## VALUE ENGINEERING PROPOSAL

DESCRIPTION: Provide a Land-Side Earth/Stone Berm to the Sheetpile Bulkhead Wall

NEW BEDFORD HARBOR SUPERFUND SITE  
UPPER AND LOWER HARBOR (OU#1)  
NEW BEDFORD, MASSACHUSETTS

DRAWING NO. 2

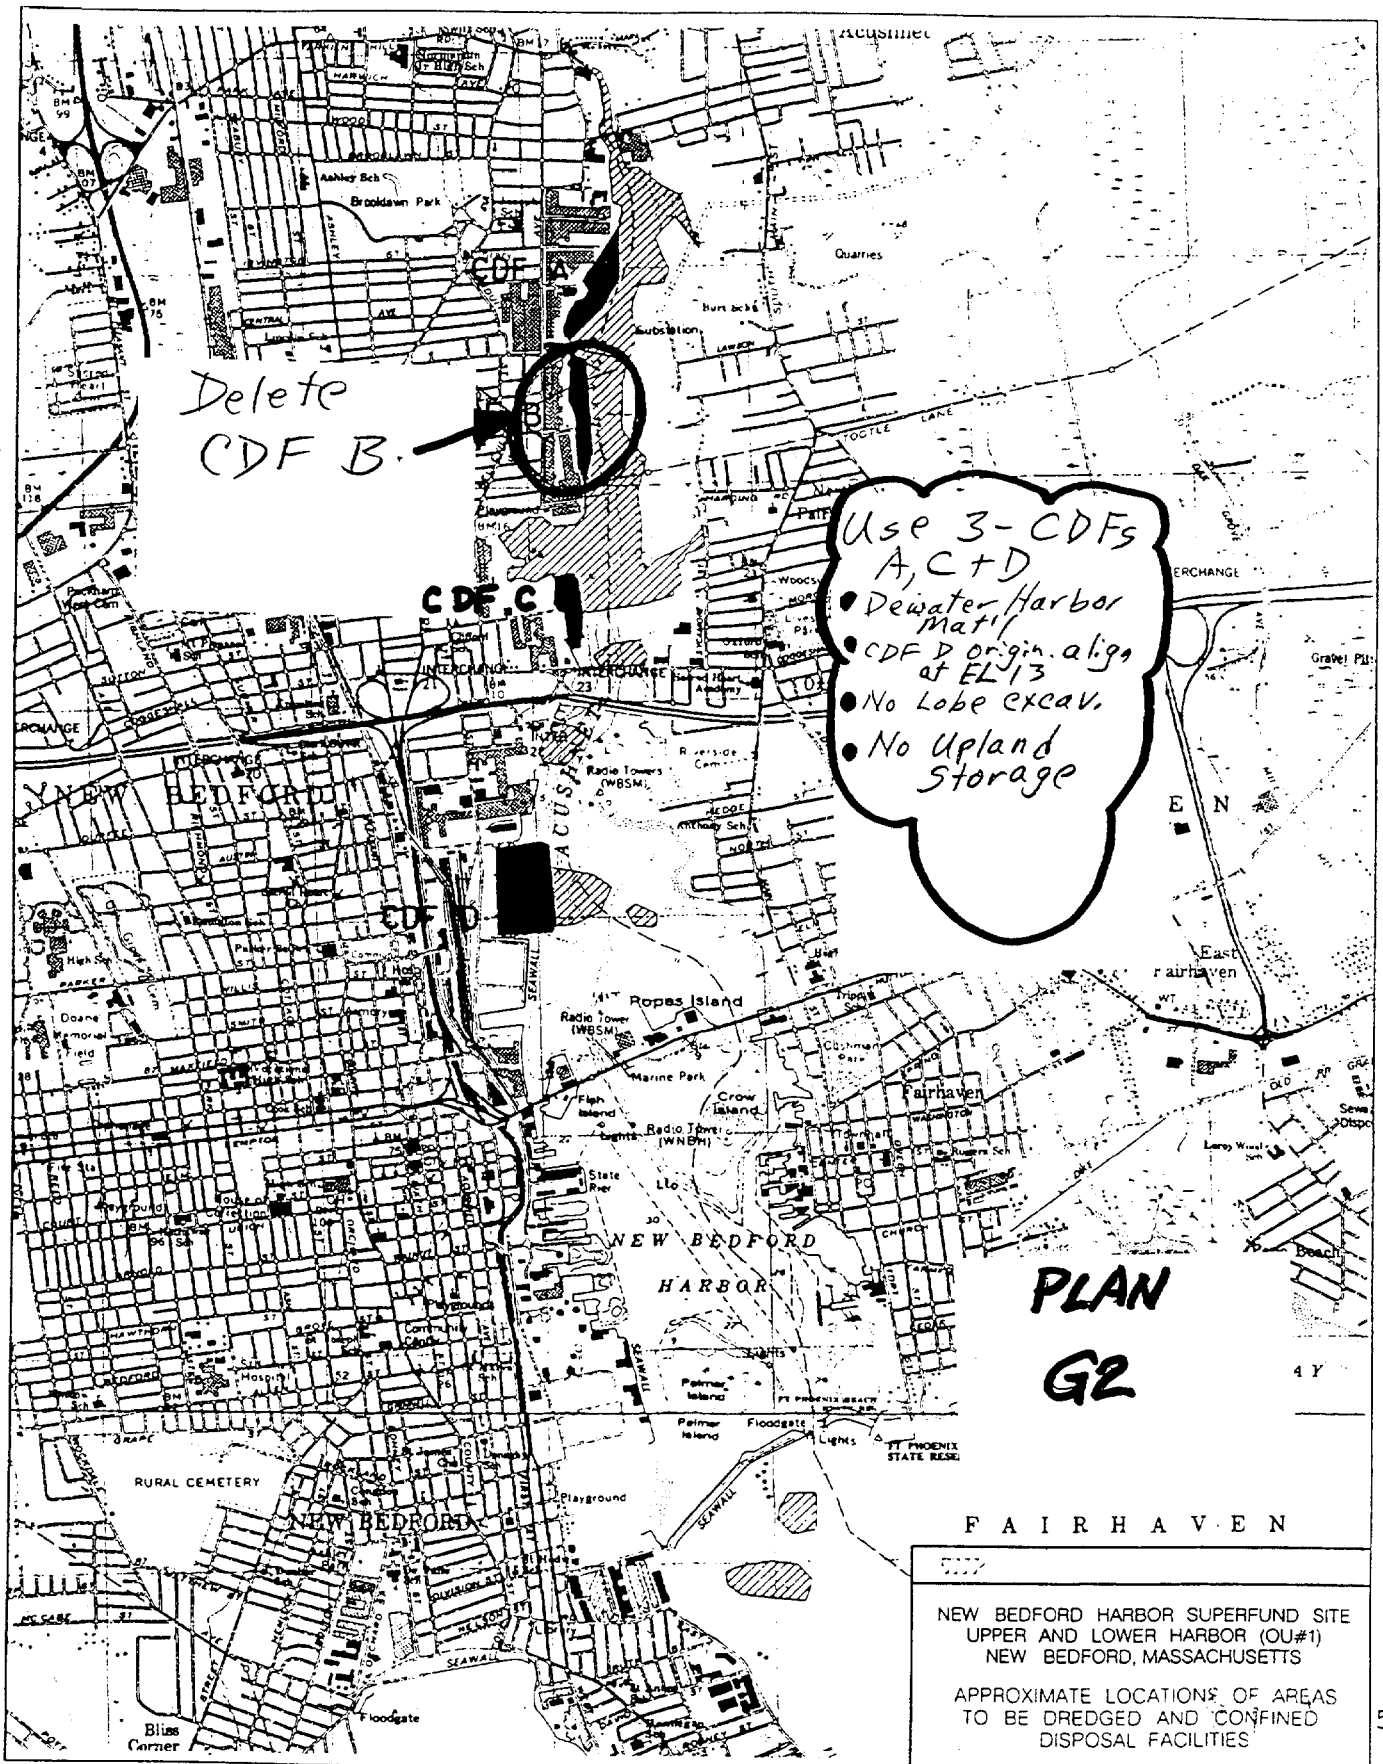
(See Drawing Nos. 2 and 3).

DRAWING NO. 2

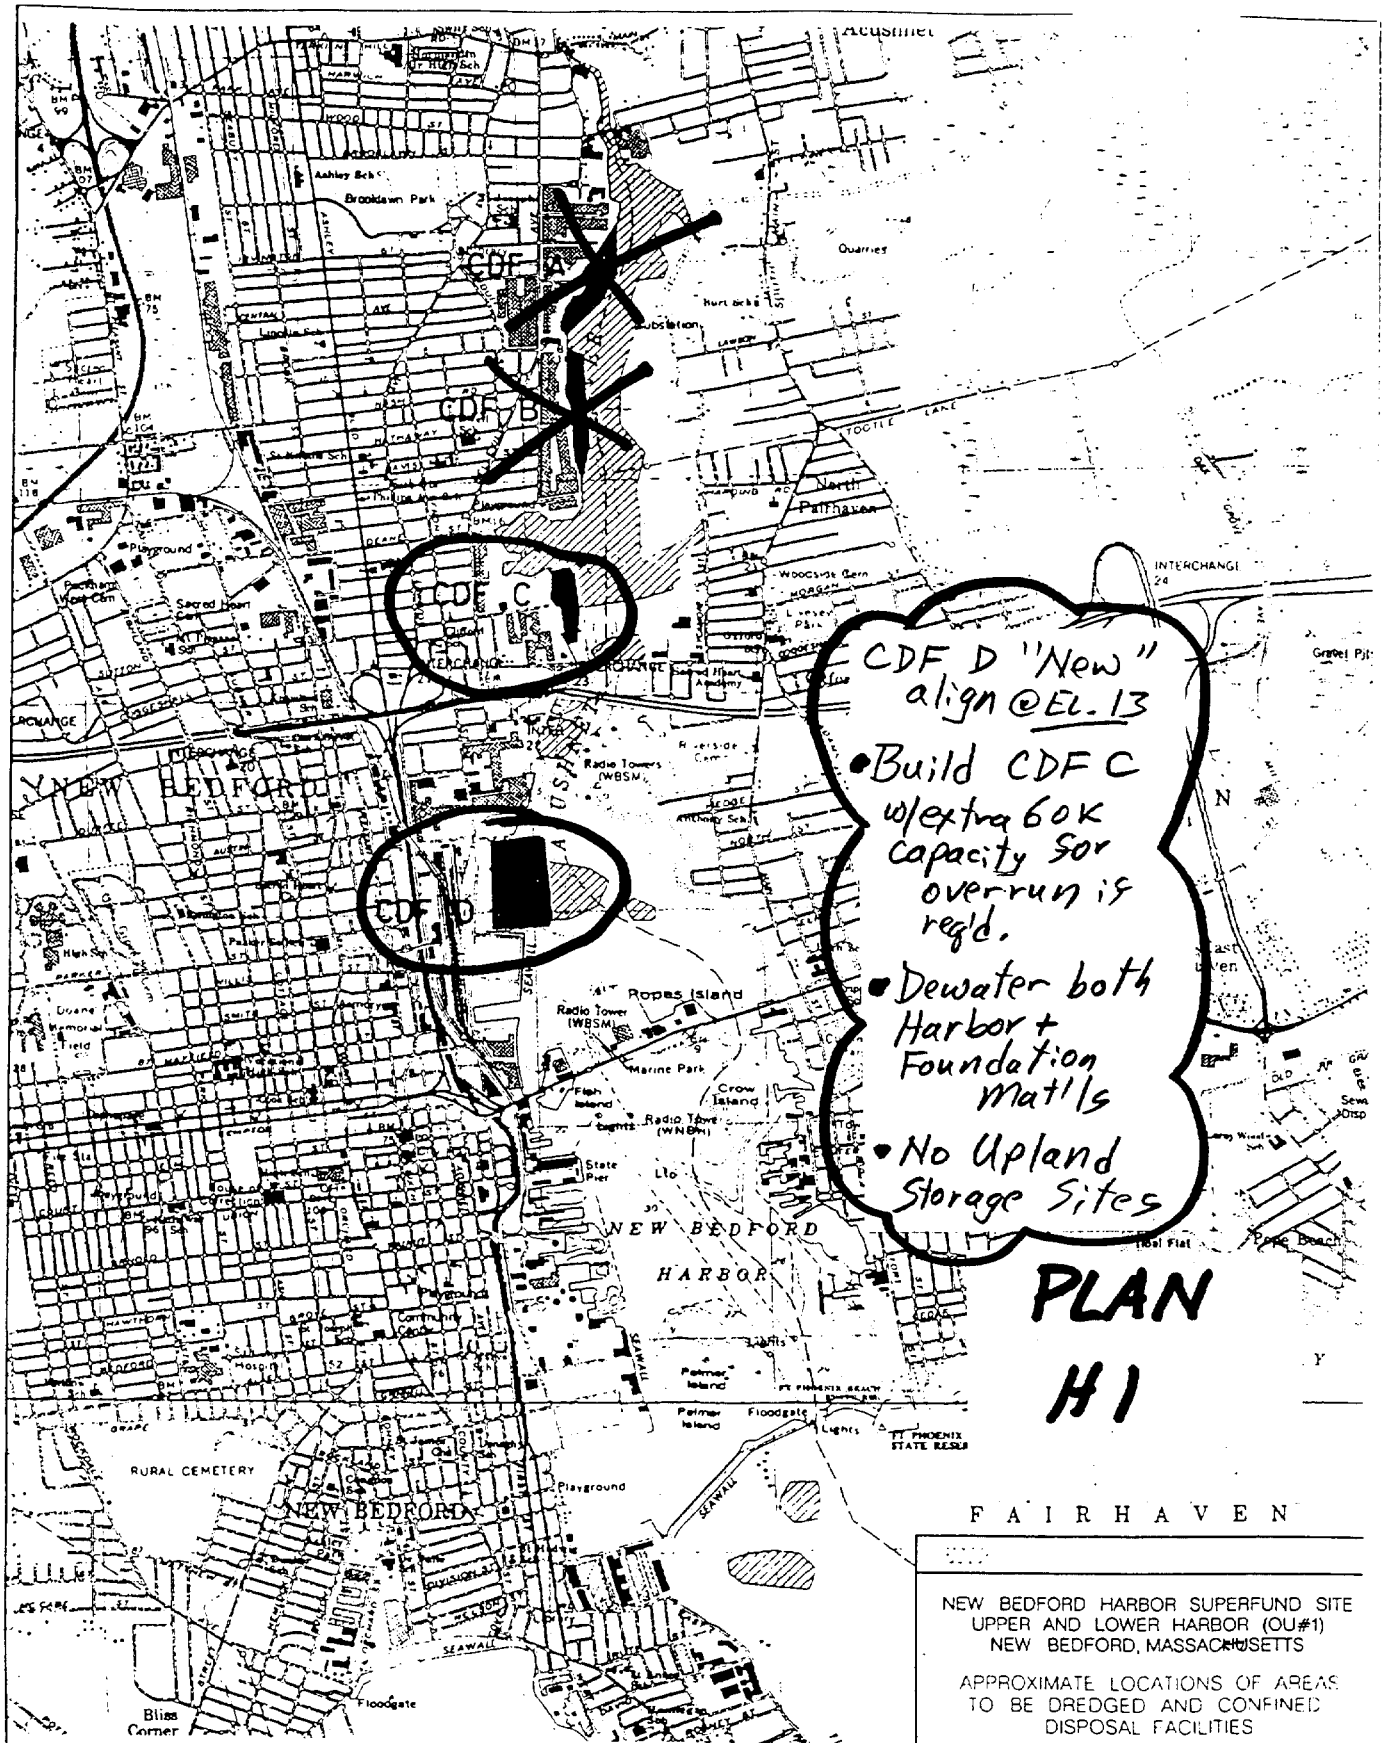
Plan H2, Option 1: Build CDF "D" new alignment to elevation 16. De-water both harbor and foundation sediments. No other CDF's or upland sites.

It may be unrealistic to assume implementability of the 3 upland sites. H1: Extra capacity available for excavation of foundation at CDF "C". Avoids CWA 404 issues since the plan would not be backfilling foundation material into excavated wetlands or mudflats. There are no savings with Option 1, Plans H1, H2, H3, or H4 unless the Option 2 situation should exist where upland storage sites are not feasible and all material from foundations would go to a Subtitle D landfill; then Plan H2 would be cost effective and most feasible.
